Delegated officer report for planning application

Application no. 139810/FH/2024

Proposal: Erection of two storey side and rear extension, extension of front bay canopy extended and erection of front and rear roof dormer to form additional living accommodation

Address: 42 Grangethorpe Drive, Manchester, M19 2NE

Submitted proposed ground, first, and roof plans

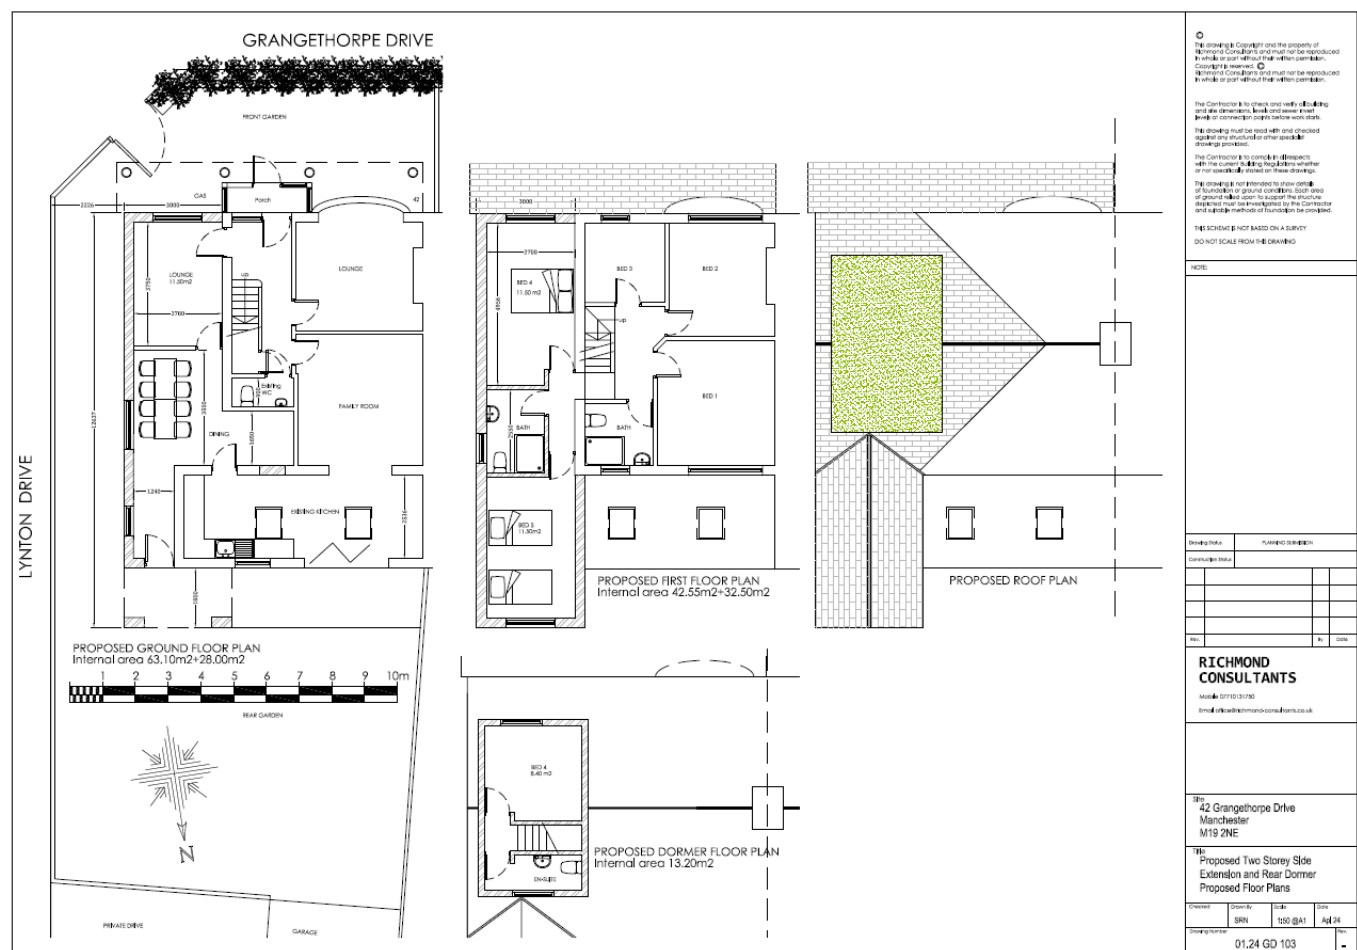
It is considered that the first-floor element of the side extension would have an unduly harmful impact upon the visual amenity of the area on account of it projecting beyond the clearly

established building lines of Lynton Drive as well as its lack of visual subservience to the host dwellinghouse and inappropriate rear roof form, which would be out-of-keeping and visually incongruous with the surrounding area. The front porch/canopy extension and front dormer extension are also considered to cause undue harm to the visual amenity of the area, representing visually incongruous and out-of-keeping structures, with no precedent for developments of this type within the surrounding area, whilst the rear dormer extension would represent an overdevelopment of the property's roof space on account of its inappropriate siting on the roof of the proposed side extension.

Overall, this element of the proposal is considered to be unacceptable on account of the unduly harmful impact it would have upon the street scene and visual amenity of the surrounding area as well as the appearance and character of the host dwellinghouse itself. This is on the basis that the first-floor element of the extension would project considerably beyond the clearly established building lines of Lynton Drive, forming a visually incongruous feature with the capacity to cause substantial visual harm. This view is further maintained as there is no existing precedent for two-storey side extensions on corner plots within this locale (see annotated image included below). The proposed side and rear extension would also fail to read as a subservient addition to the host dwellinghouse as a result of its failure to include an adequate first-floor setback and reduced ridge height. Its dual pitch roof form to the rear is also considered to be an inappropriate and unsympathetic design choice, which would be out-of-keeping with the appearance and character of the existing dwellinghouse, surrounding residential properties and other two-storey rear extensions situated within the immediate vicinity of the site, including No.46 Grangethorpe Drive.

View along Lynton Drive

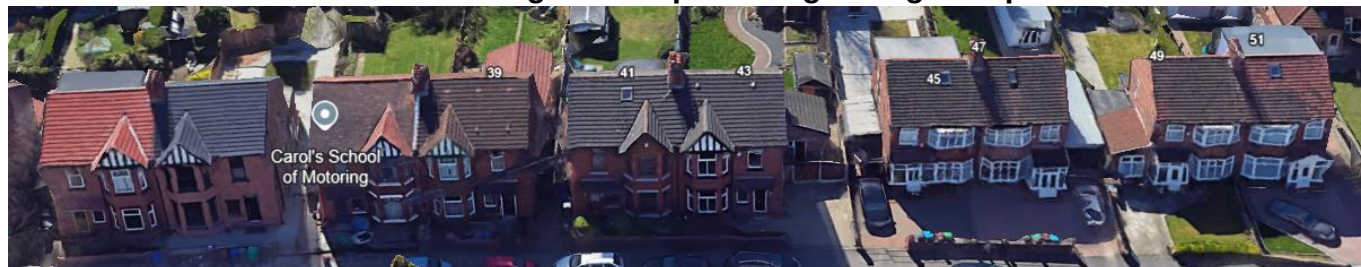
Overall, this element of the proposal is considered to be unacceptable on account of the unduly harmful impact it would have upon the street scene and visual amenity of the surrounding area. The design and appearance of the canopy extension is not considered to be sympathetic to the appearance and character of the host dwellinghouse and would be out-of-keeping with the surrounding dwellinghouses, which predominantly feature traditional front porch canopies and conservatory-style additions, with a distinct lack of classical-style column support posts. This element of the proposal would therefore represent a visually incongruous feature within the area, which would detract from the traditional historic character and appearance of the surrounding built form (see images included below).
